DOCKET NOS. 50-266 AND 50-301
ADDITIONAL INFORMATION
SPENT FUEL STORAGE EXPANSION
POINT BEACH NUCLEAR PLANT UNITS 1 AND 2

Mr. Schwencer's letters dated September 11, 1978 and October 3, 1978, forwarded a number of requests for additional information regarding our proposal to expand the spent fuel storage capacity at our Point Beach Nuclear Plant, Units 1 and 2. Our request for permission to increase the spent fuel storage capacity at Point Beach was submitted on March 21, 1978, and has been subsequently amended on June 14, 1978 and September 29, 1978. Your previous requests for additional information, dated June 5 and June 9, 1978, were responded to with our letter of July 19, 1978. Some of the questions in this current information request have asked for clarification of items discussed in our July 19, 1978 responses.

The attached responses have been numbered to match the respective information requests from your September 11, 1978 letter. These responses are prefixed by the letter C. Response number A-2 from our July 19, 1978 letter has been revised to address the concern identified in your October 3, 1978 letter. In addition, we have enclosed revisions to our previous responses

FIGURE B.1

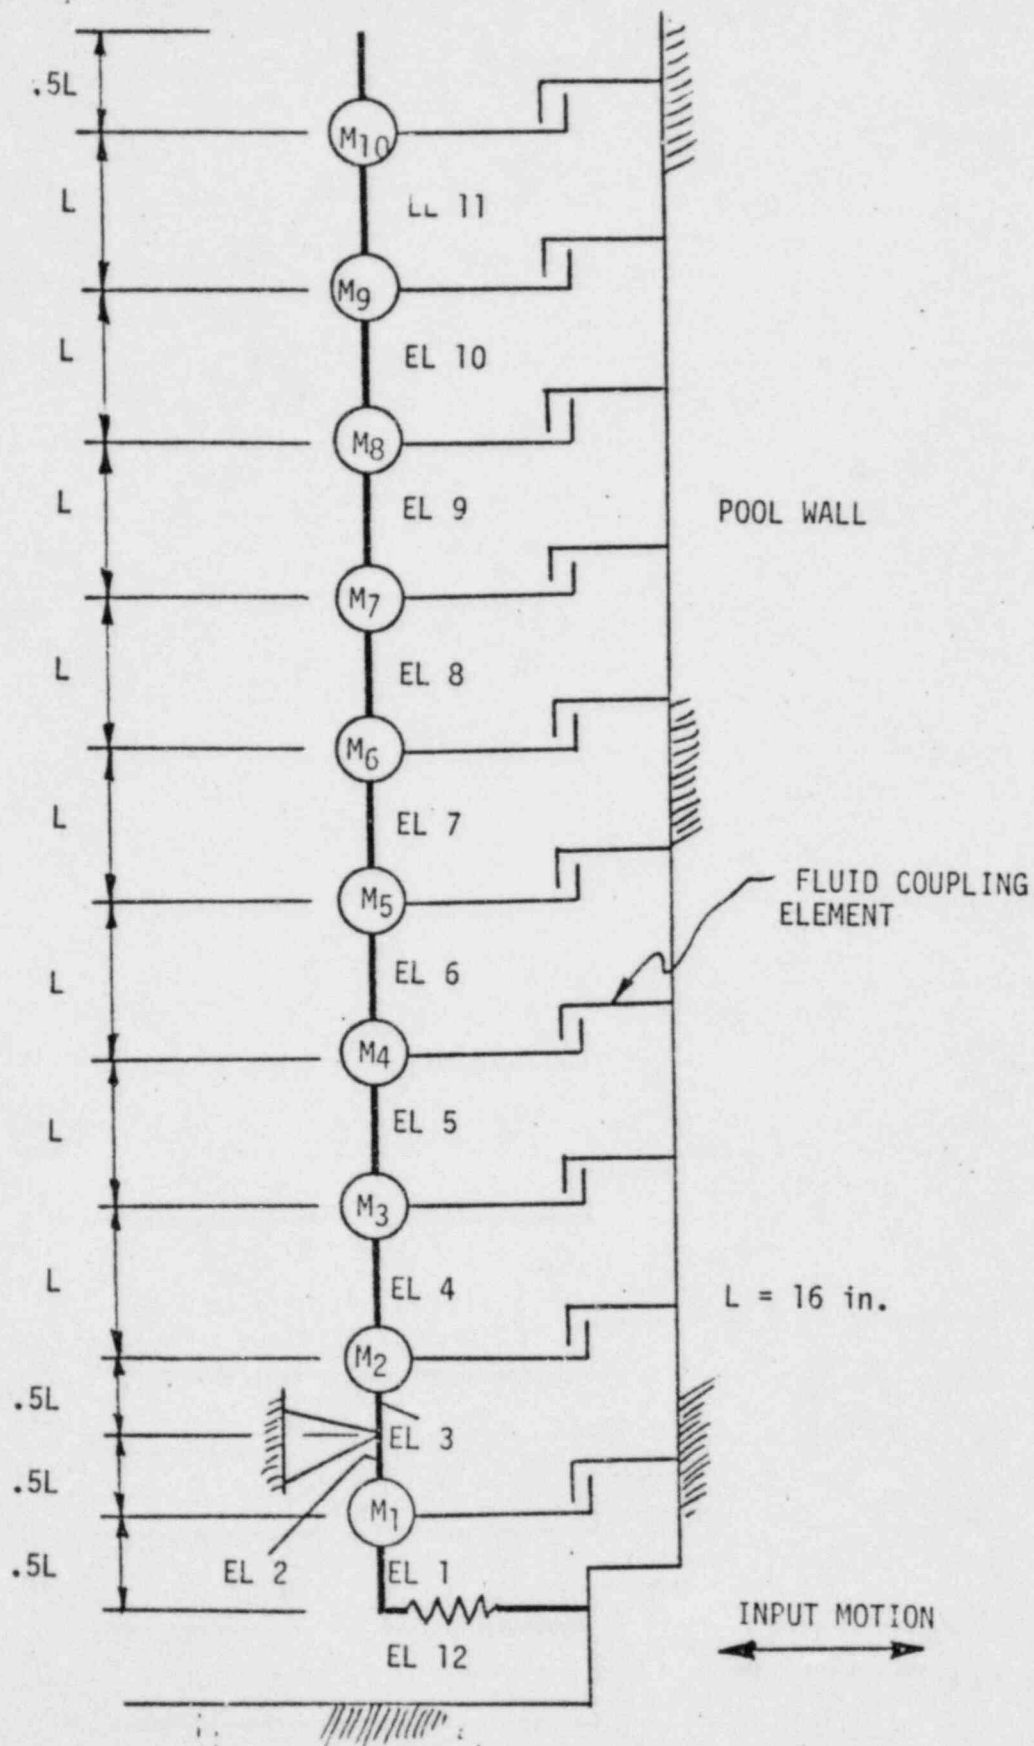
Provide details of the seismic analyses performed on the racks. Provide sketches of the math models utilized. Also, provide the frequencies up to 33 Hz, the corresponding mode shapes and participation factors. Indicate the damping values used and discuss the applicability of Regulatory Guides 1.60 and 1.61. Discuss the methods utilized to consider the effects of the gaps between the restraints and pool walls, and indicate whether the racks are physically connected to one another or if it is possible for adjacent racks to impact. Also, provide a summary of the resultant highest stresses and strength ratios, and the corresponding locations.

The mathematical model is shown in Figure B.1. In this model masses M1 through M10 each represent one-tenth of the mass of the following: a) the rack structure, b) the fuel bundles, c) the poison assemblies, d) the entrapped water and e) the hydrodynamic mass. Flexible elements EL1 through EL11 represent the bending flexibility and the shear flexibility of the rack itself, considered as a beam. EL12 represents the local flexibility of the bottom part of the rack structure. The support between M1 and M2 represents the support that is placed between the rack and the pool wall to prevent horizontal motion of the rack relative to the pool wall. The fluid coupling element between each mass and the pool wall represents the effect of the motion of the pool wall on the rack structure due to hydrodynamic coupling. Calculations similar to those done in determining the hydrodynamic mass were performed and are similar to those described by Fritz, except that in the present case the pool wall is considered to move with the motion of the ground. It was found that the effect of this coupling can be accounted for by modifying the model participation factor in the dynamic design method.

FIGURE 1

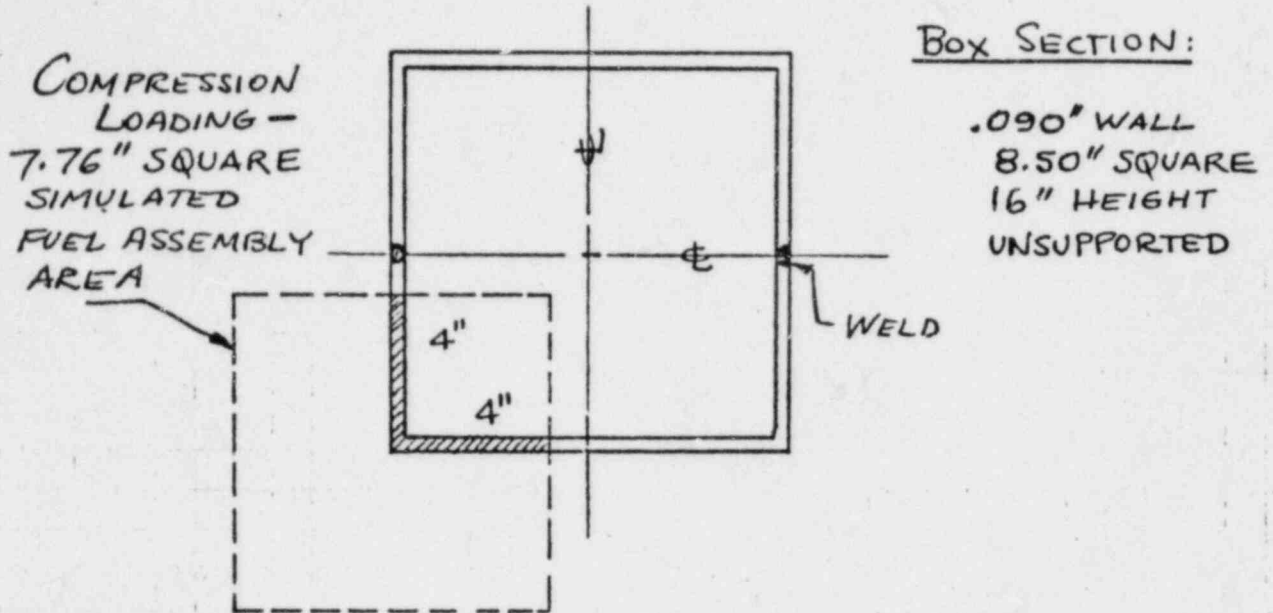
It is our position that the effects of a dropped fuel assembly must be considered. Discuss and quantify the local and gross affects on the racks, fuel pool liner and floor for the following three cases of a dropped fuel assembly:

- a) a straight drop on the top of a rack
- b) an inclined drop on the top of a rack
- c) a straight drop through a can with the fuel assembly impacting the bottom of a can at both a flexible location of the rack and right at a vertical support location.

confined to the upper 2" of the box, thus reinforcing the concept that the impact damage will be highly localized. The total energy absorbed by the box sections was 715-760 ft-lbs. of energy. While the experiment was simple and the loading slowly applied, the results are considered to be applicable to a worst case rack deformation evaluation. With an impact loading situation it is expected that less deformation would occur because generally material strength, and ability to absorb energy, are greater at higher loading rates.

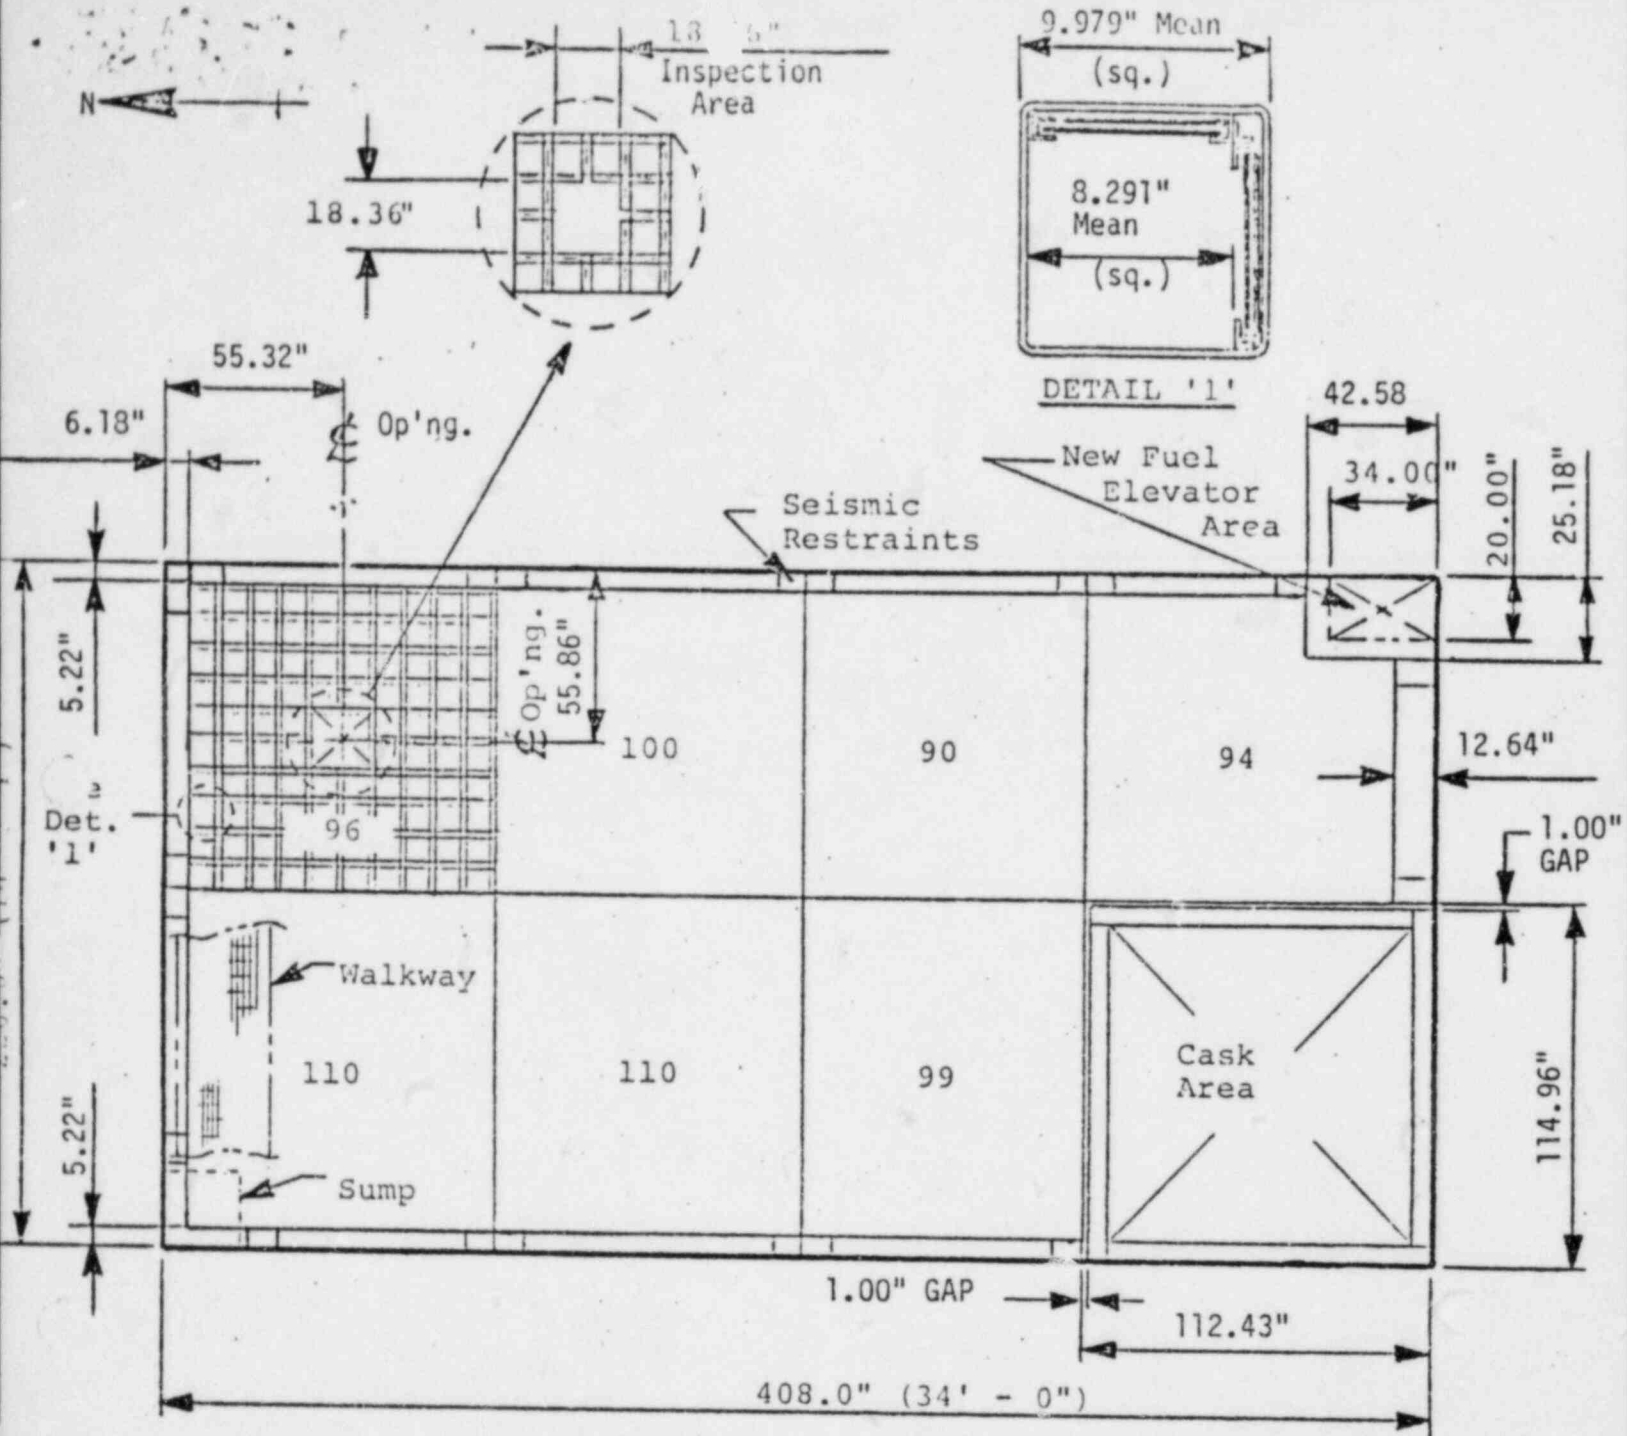
NRC procedures require that an onsite test be performed to verify, within 95 percent confidence limits, that a sufficient number of neutron absorbing plates (i.e., poison plates) in the installed racks contain the required boron content to maintain the $k_{eff} \leq 0.95$. When the poison plates are made an integral part of the racks and the condition of the poison plates is continually monitored by surveillance tests, the NRC finds that a single initial neutron attenuation test on the racks is sufficient. However, a single initial neutron attenuation test will not be sufficient for the proposed racks with the removable poison inserts. Describe how you propose to periodically perform tests to verify, within 95 percent confidence limits, that there will always be a sufficient number of poison plates which contain the required boron content to maintain the $k_{eff} \leq 0.95$ in the proposed storage racks with the removable poison inserts.

The rack design provides two semi-permanent poison assemblies per fuel assembly. These poison assemblies are locked in place by a lock bolt that cannot be removed without mechanically deforming the locking element. The lead-in funnel at the top of the fuel cell location is an integral part of the poison assembly and thus the presence of the neutron poison plates can be verified visually. The presence of the neutron poison plates will be verified visually prior to the installation of the storage racks in the pool. (See attached Figure 2-1)
